BC Ambulance Service BC Emergency Health Services	<h2>Power Inverter Diode Installation</h2>	November 21, 2016 Page 1 of 3
AMBULANCE TYPE:	Demers Chevrolet Ambulances	
UNITS AFFECTED:	63300-63349, 63360-63369, 63400-63457

ISSUE: GM Recall “42230 Shortened Powered Accessory Availability” reprograms the vehicle’s PCM and BCM for the alternator to produce more voltage. This higher voltage causes the ambulance power inverter to produce an “Over Voltage” trouble code, causing the power inverter to stop working.

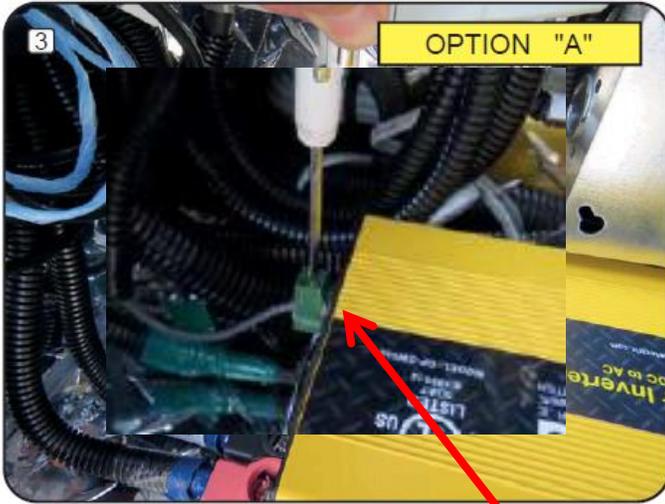
Use a screwdriver to remove wire.

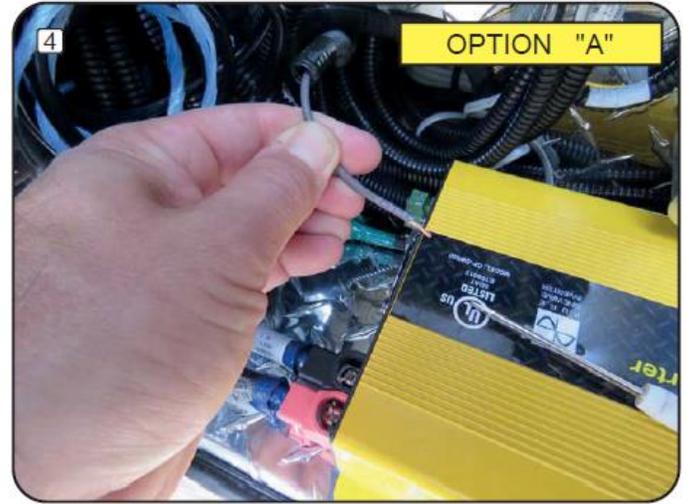
Remove wire.

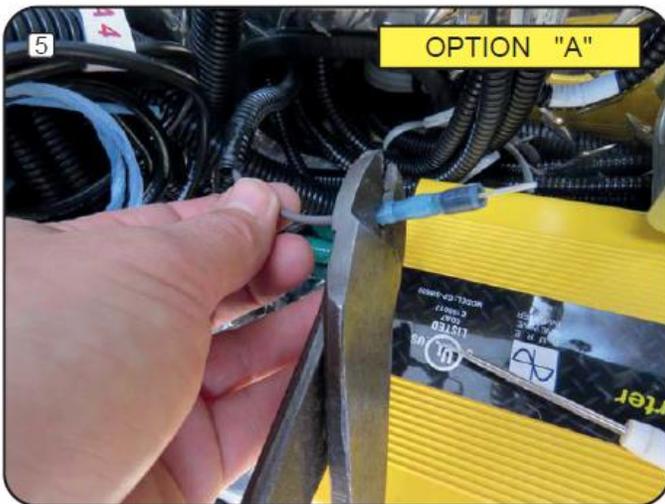
Crimp and heat shrink diode assembly.

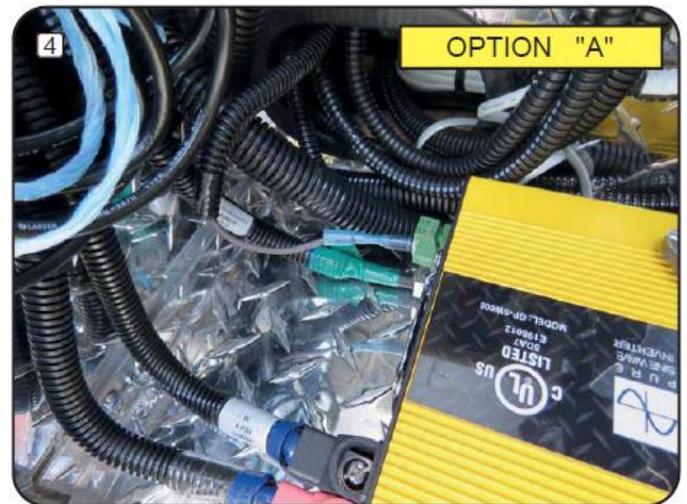
Reinstall wire in connector.

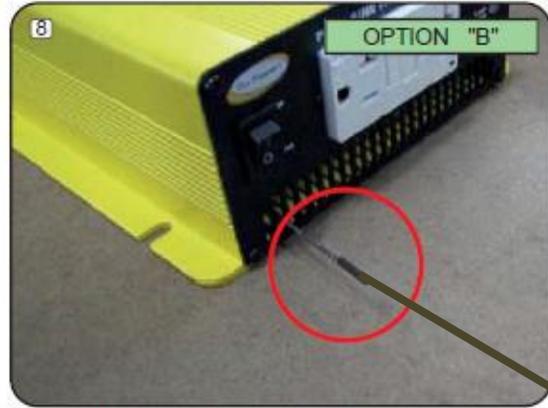
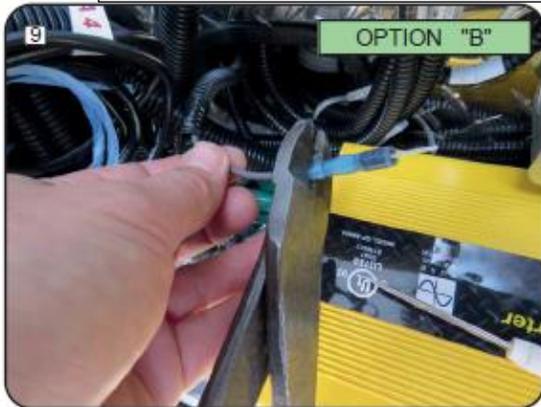
- 1) Locate switching wire entering inverter. 2) Cut switching wire and insulate inverter end.
- 3) Re-route the harness wire to opposite end of the inverter.

Crimp and heat shrink diode assembly.

Install wire in connector.
See below schematic.
